# WRITTEN REPRESENTATION FOR SPR EA1N and EA2 PROJECTS (DEADLINE 1)

## SITE SELECTION

**Interested Party:** SASES    **PINS Refs:** 20024106 & 20024110

**Date:** 2 November 2020

**Figure 2. Surface Water Flood Risk to SPR selection zones (except Broom Covert)**

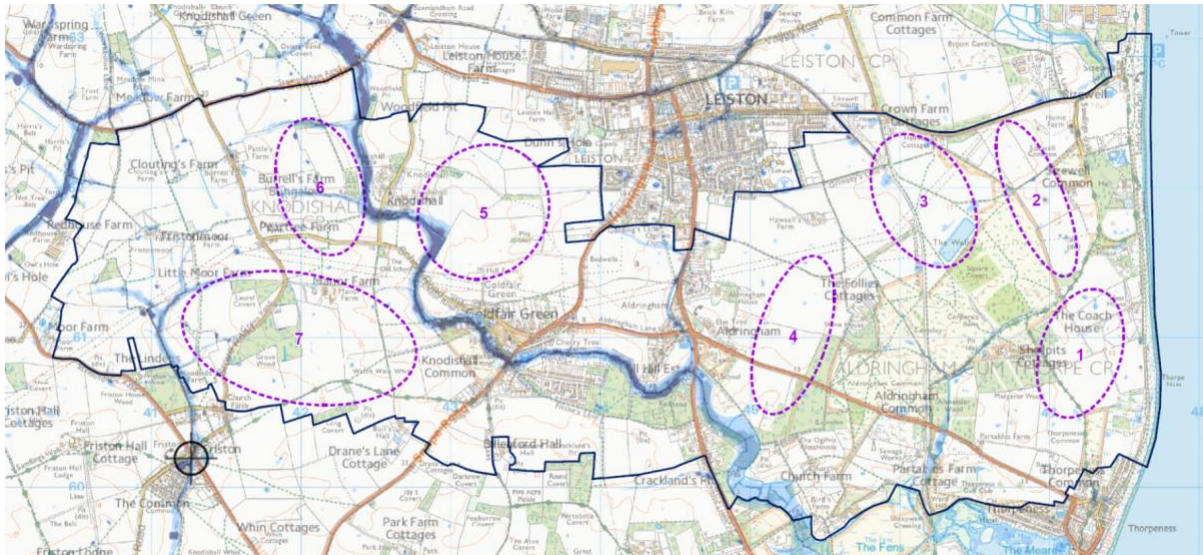
- However, this wording does not seem consistent with the actual surface water flood risk shown in the Environment Agency map (see Fig. 1 below which has been assembled from Figure 20.1.2 of Ref. 4 and the OLMP plan from Ref. 5). The NGET substation is the structure on the North-West side. The required Pylon and Sealing End Compounds and structures are also shown, and also fall within the surface water flood area.

- Given this clear flood risk to the NGET substation area and adjoining land required for NGET realignment and other works as part of the linked NSIP, the applicant's obligations under the NPPF (as confirmed by NPS EN-1, EN-3 and EN-5) are understood to require the Sequential Test for flood risk to be undertaken, whereby the Grove Wood site is compared with other relevant sites also in Fluvial Flood Zone 1. There is no evidence that this has been done. Indeed it is not clear how the Grove Wood NGET site could pass such a test given that sites adjacent to the overhead lines in the other zones considered by SPR as part of their Site Selection process can be seen as not having a surface water flood risk (Figure 2 below). (Note that Zone 7 is also referred to as 'W1').

- It is clear, therefore, that SPR now accept that the National Grid site area **is** subject a serious surface water flood risk and in that case a **Flood Risk Sequential Test** would have been expected as part of the overall Site Selection and DCO Application processes. But no documented evidence has been found that this test has been carried out across the various sites available (see Figure 2 and Broom Covert), or that the test has been approved by the relevant Local Authority (ESDC and/or SCC). The selection of Grove Wood as the site for EA1N, EA2 and NGET substations and associated overhead line works must therefore be unsound.
